Educational Suitability Summary Report

Travis High School – BLDG 007

Date: 05/16/2016 (REV1 – 12/12/2016 CAC comments)

(REV 2 – 1/3/2017 – comments from Juanita Reyes)

Photo 3. Science Vent Hood

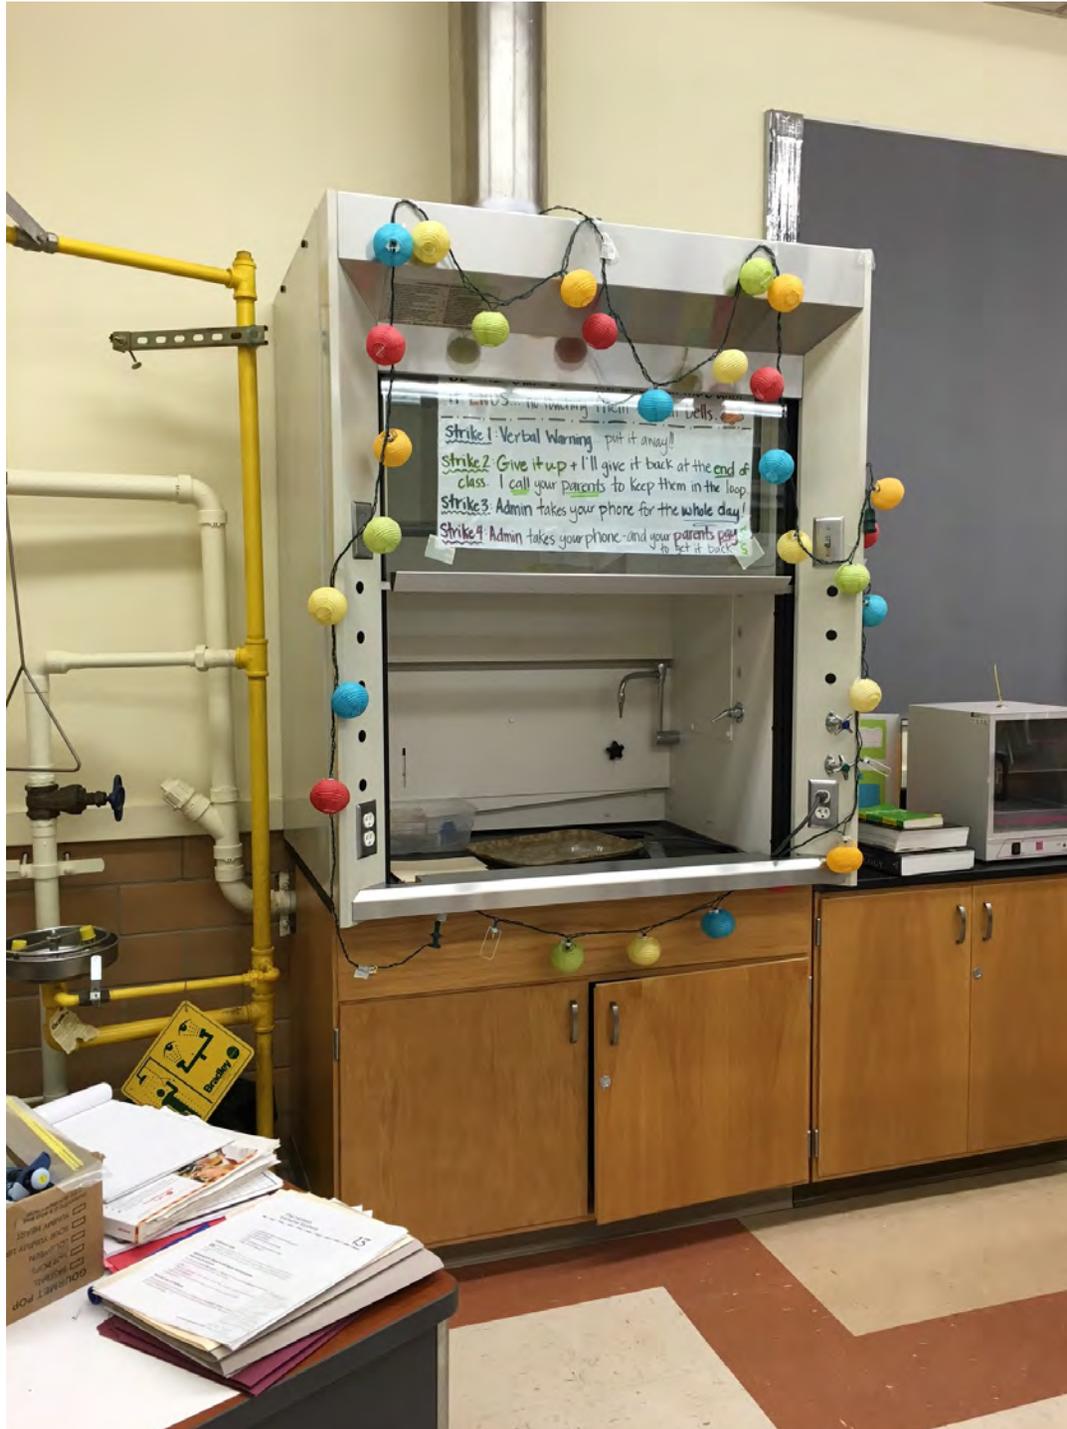
3.5	Are Science Classrooms/Labs support areas appropriately configured per the ed spec?			3				Comments	1.00 3.00
1) Very unsatisfactory - Support spaces are disconnected from served spaces, too small, do not meet needs 2) Unsatisfactory - Support spaces are connected, but too small, do not meet needs 3) Average - Connected, moderate size, but need some renovations or updates 4) Good - Connected, good size, meets needs, functions well 5) Very good - connected, generous size, nice condition, functions appropriately N/A) Does not apply. (Elementary schools)		Prep room is not visible to classroom. Chemical storage room located in another classroom and not centrally located for all science staff.
